**SUBJECT:** NuScale Power, LLC Supplemental Response to NRC Request for Additional Information No. 71 (eRAI No. 8889) on the NuScale Design Certification Application

NuScale Supplemental Response to NRC Request for Additional Information eRAI No. 8889

**NRC Question No.:** 19-13

Figure 19.1-13: Contribution to Internal Events Core Damage Frequency by Initiator (Point Estimates)

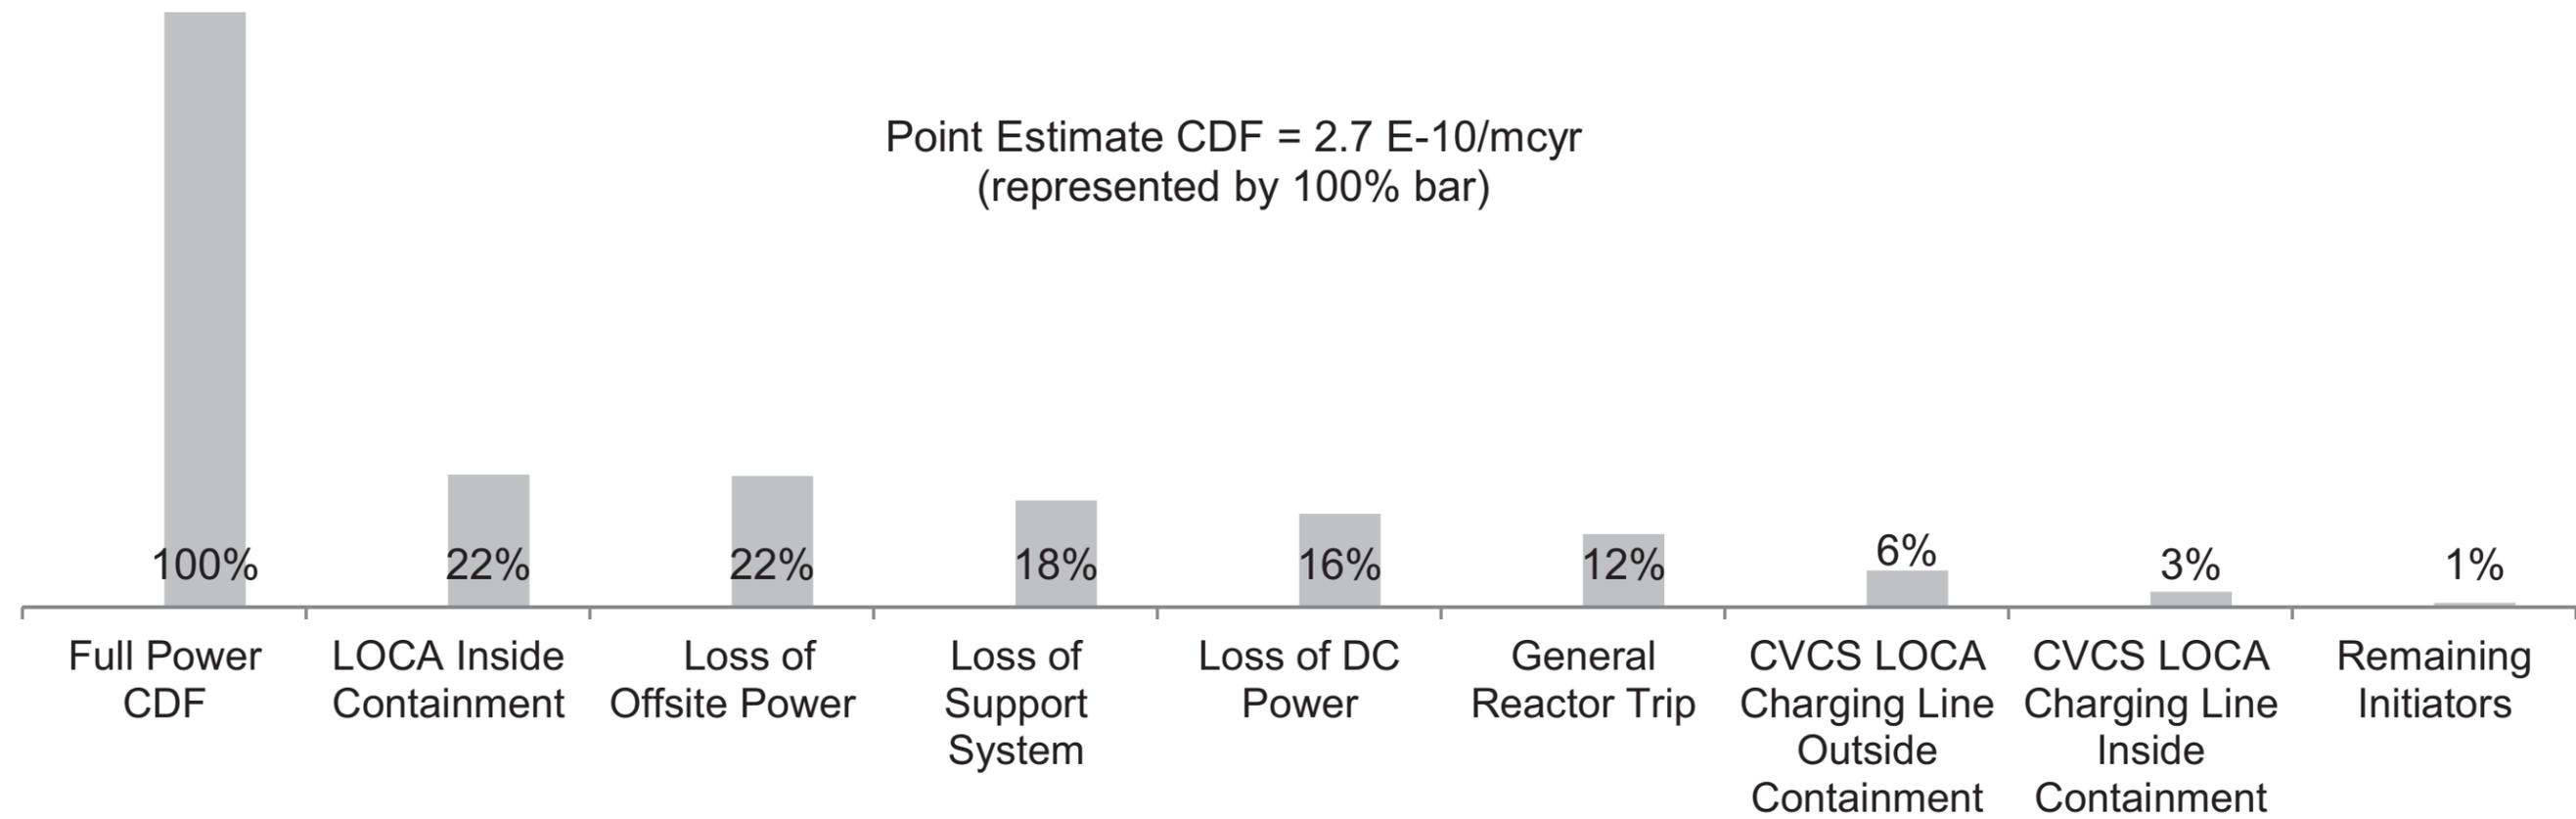
FSAR Sections 19.1.4.2.2, 19.1.9.1, 19.2.3.3.6; FSAR Tables 19.1-10, 19.1-22, 19.1-28, 19.1-31, 19.1-80; and FSAR Figures 19.1-13 and 19.1-14 have been revised as described in the response above and as shown in the markup provided in this response.

Figure 19.1-14: Contribution to Internal Events Large Release Frequency by Initiator (Point Estimates)

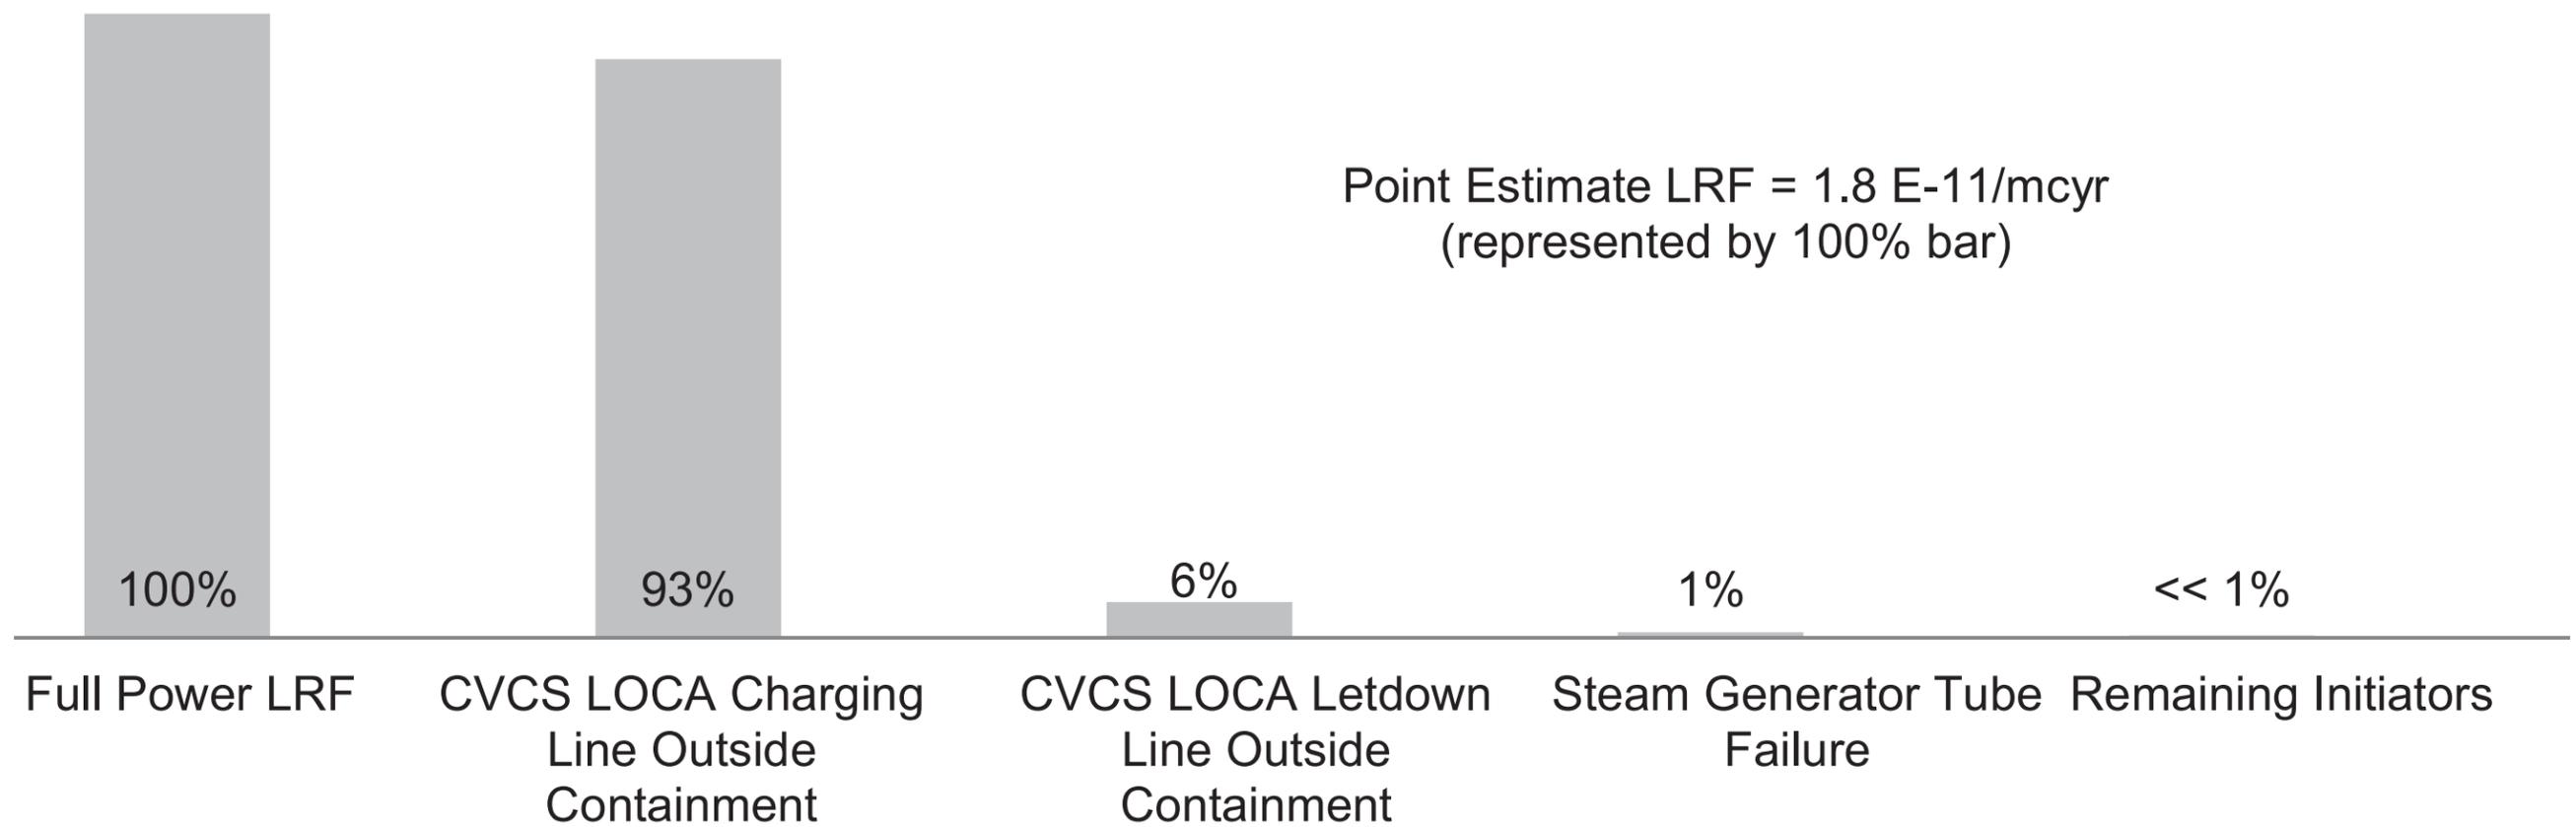
The probability of a thermally induced SGTF has been updated in FSAR Table 19.1-10. This change has a negligible effect on the large release frequency (LRF), as illustrated in the revised LRF values summarized in FSAR Sections 19.1.4.2.2, 19.1.9.1 and Table 19.1-80. The format of Figure 19.1-14 has been simplified and reflects a negligible change in the LRF. There is no change in the core damage frequency; however, the format of Figure 19.1-13 has been modified for consistency with Figure 19.1-14. The change in the probability of a thermally induced SGTF does not introduce new candidates for risk significance.
